CHANGE TO THE CENTER CRANKSHAFT JOURNAL FIT MARKINGS

Applicable production Models and Engine Serial Nos.:

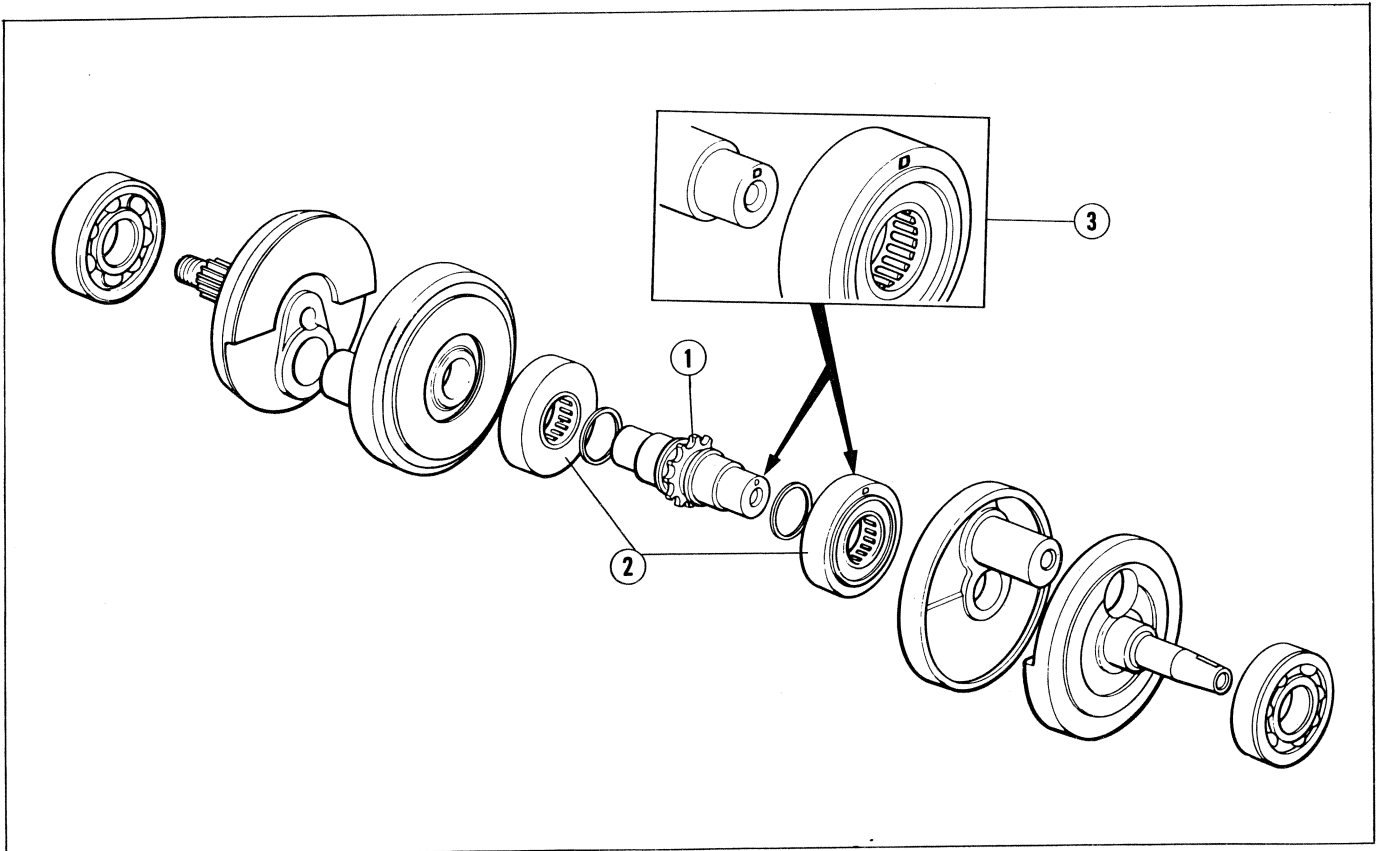
The fit markings of the center crankshaft journal have been changed as shown in the table below.

When replacing center crankshaft and center bearing assy, select the crankshaft and bearing with the same markings according to the right side table.

Center crankshaft marking	Center bearing assy. marking
∪ or A	A
□ or B	B
∧ or C	C
≡ or D	D
ホ or E	E
